PCN

Termination of CSA certification for EPCOS PhiCap PFC capacitors

Enclosure PCN (ID No. FILM P20-06)

Ordering code
B32340*
B32343*
B32344*

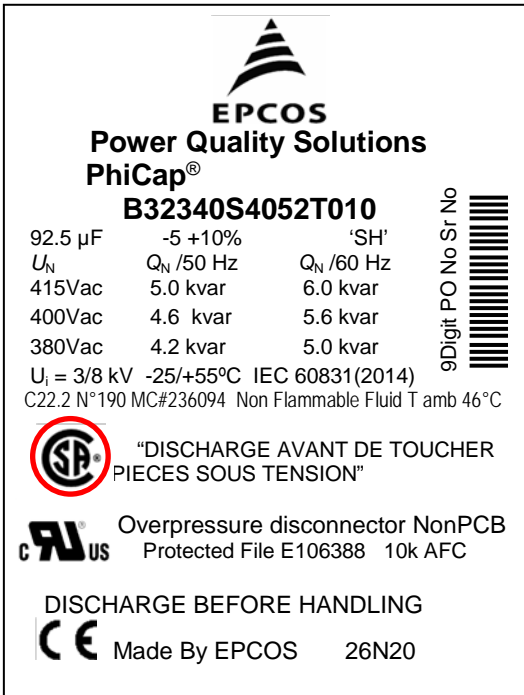
The CSA certification for the following EPCOS PhiCap® PFC capacitors will be terminated. These products will no longer carry the CSA marking on the label. The products themselves remain unchanged.
